CITY OF ALBUQUERQUE

**Re: Kidz Academy,
10751 Fineland Dr. NW, 87114
Request for Certificate of Occupancy
Transportation Development Final Inspection
Engineer's/Architect's Stamp dated 5-31-18 (A11D016)
Certification dated 1-18-19**

DRAWING TITLE
SITE PLAN

SITE PLAN

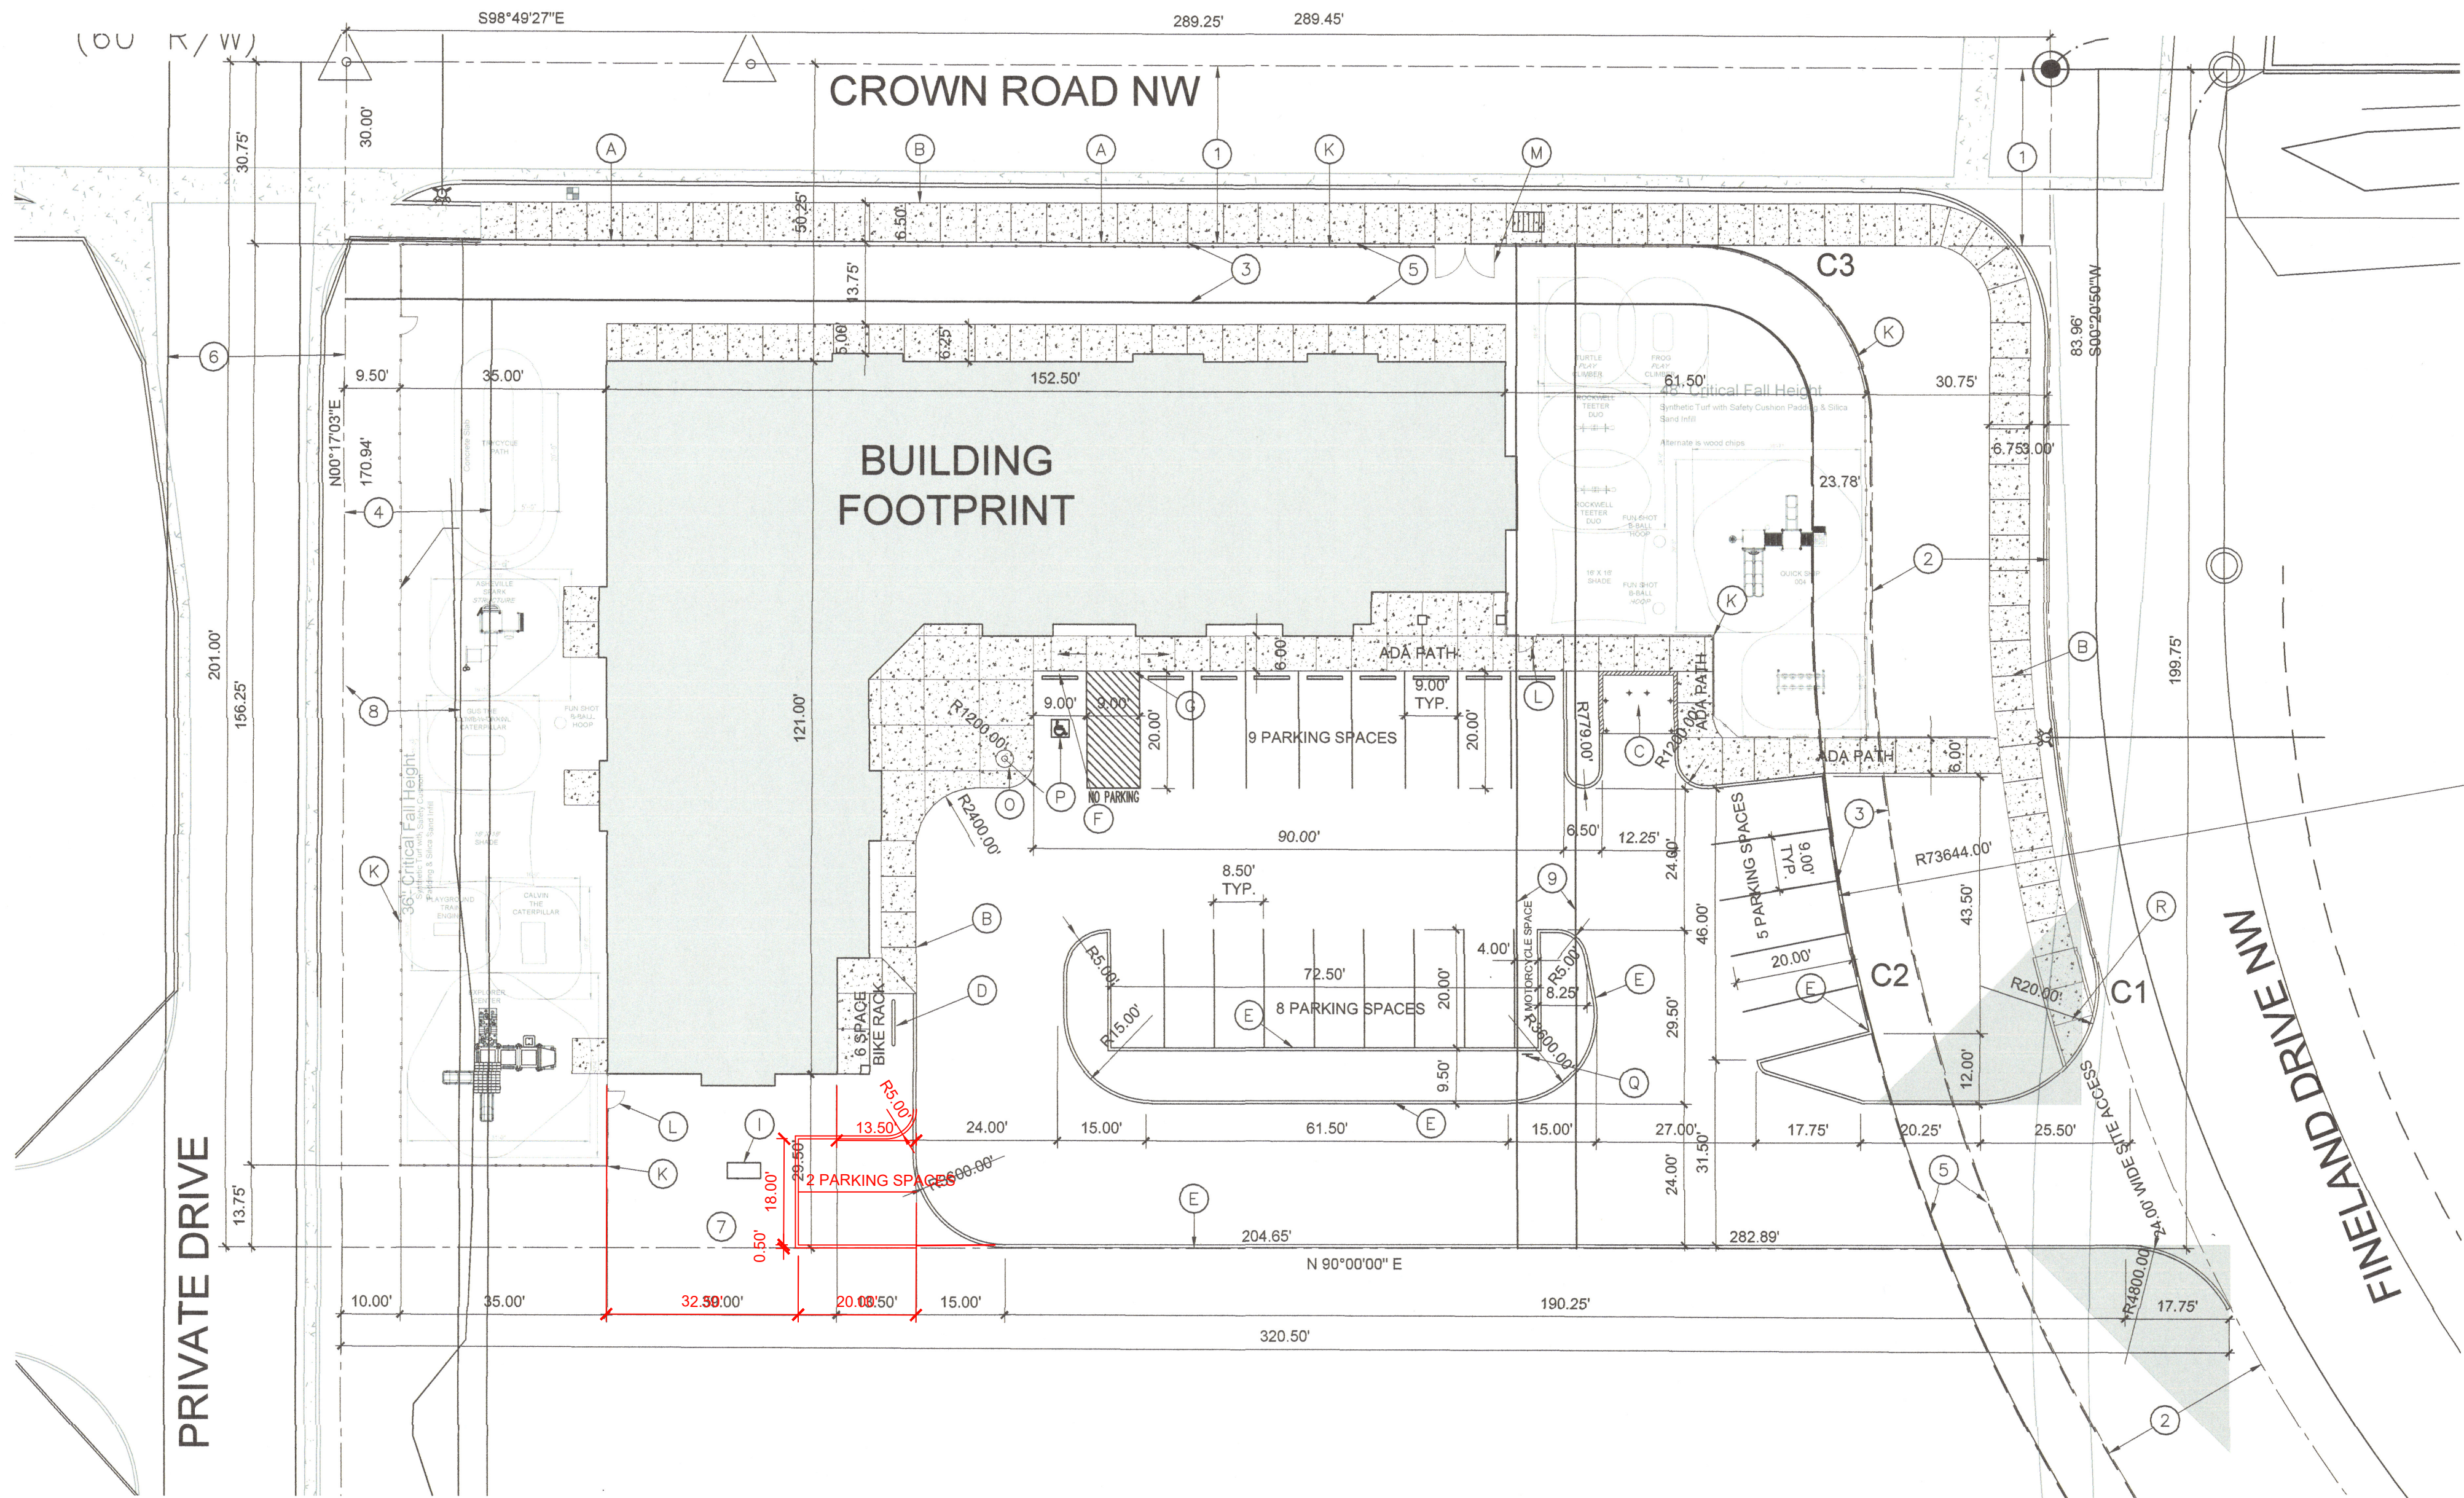
- Please submit an Administrative Amendment (AA) reflecting all changes to the approved DRB plan.
- The ADA accessible parking sign must have the required language per 66-7-352.4C NMSA 1978 **"Violators Are Subject to a Fine and/or Towing."**
- Per the IDO, a 6 ft. wide ADA accessible pedestrian pathway is required from the public sidewalk to the building entrances. (Walk path was relocated and width measurement was 4 foot, please correct.)
- Minimum width for parking stalls is 8 foot 6 inches. Please correct parking stalls at island with 8 stalls and 1 motorcycle parking. (Measurement taken at site, 8 foot)
